**CITY OF PORTLAND, MAINE  
DEVELOPMENT REVIEW APPLICATION  
PLANNING DEPARTMENT PROCESSING FORM  
Planning Copy**

UNE College of Pharmacy  
Project Name/Description

City of Portland Staff Comments are shown below in *italics*, our response to comments is in **bold**.

**RE: Site Plan Review**  
**University of New England College of Pharmacy**  
**716 Stevens Avenue**  
**Application #2007-0158; CBL 0144 A005001**

Figure 2  
SITE GENERATED WEEKDAY PM PEAK HOUR TRAFFIC - EXPANDED 1/07  
PROPOSED UNE COLLEGE OF PHARMACY / PORTLAND, MAINE

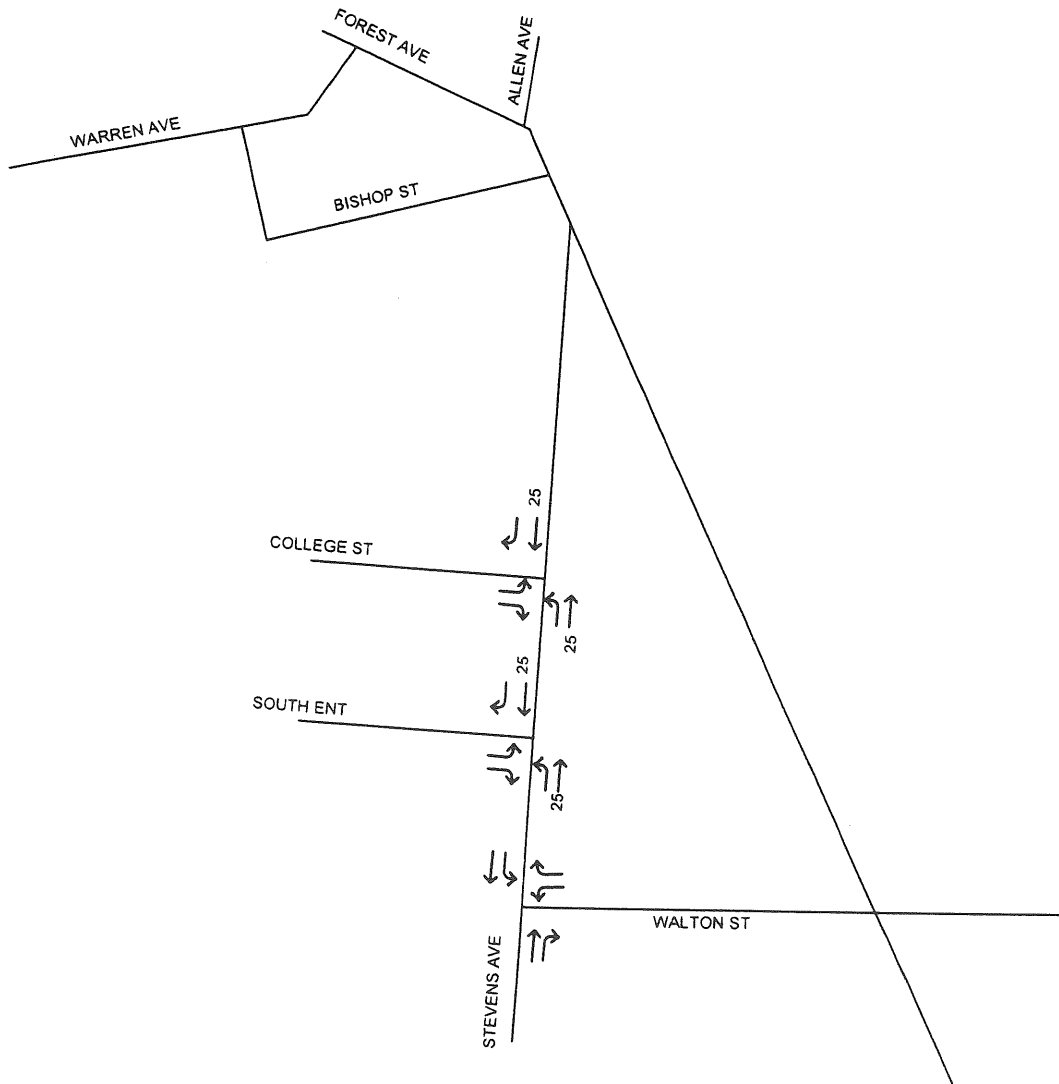
Post-development weekday PM peak hour volumes are the combination of pre-development volumes presented in Figure 3D, and site generated traffic presented in Figure 2 (Revised figure attached showing site generated traffic in Morrill’s Corner per the request of the City of
